"Summertown CPZ amendments" - consultation response by Oxfordshire Liveable Streets and Cyclox, February 2026

Lonsdale Rd

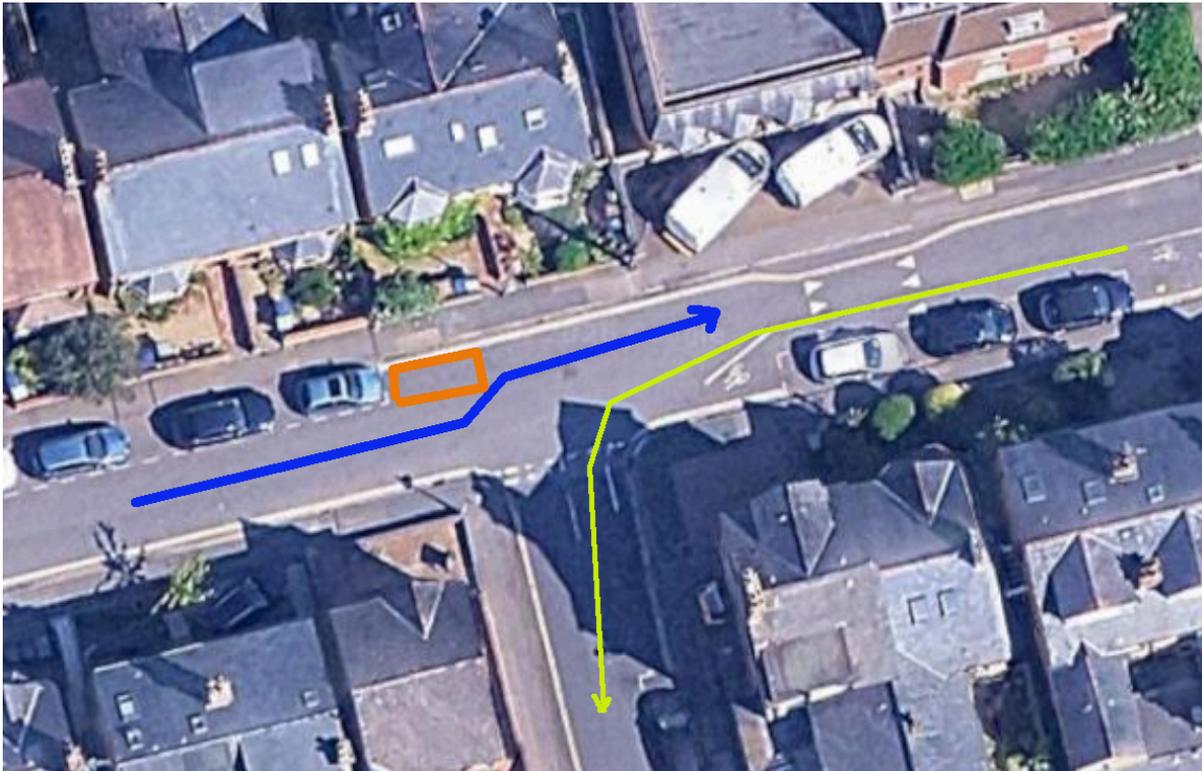
This is a useful location for both cycle and micromobility parking.

A small suggestion is that it might be better to have the micromobility parking at the western end, closest to Banbury Rd - that is to swap the cycle and micromobility bays. Overflow micromobility parking might sprawl along the DYs, but that would not be a hazard here.
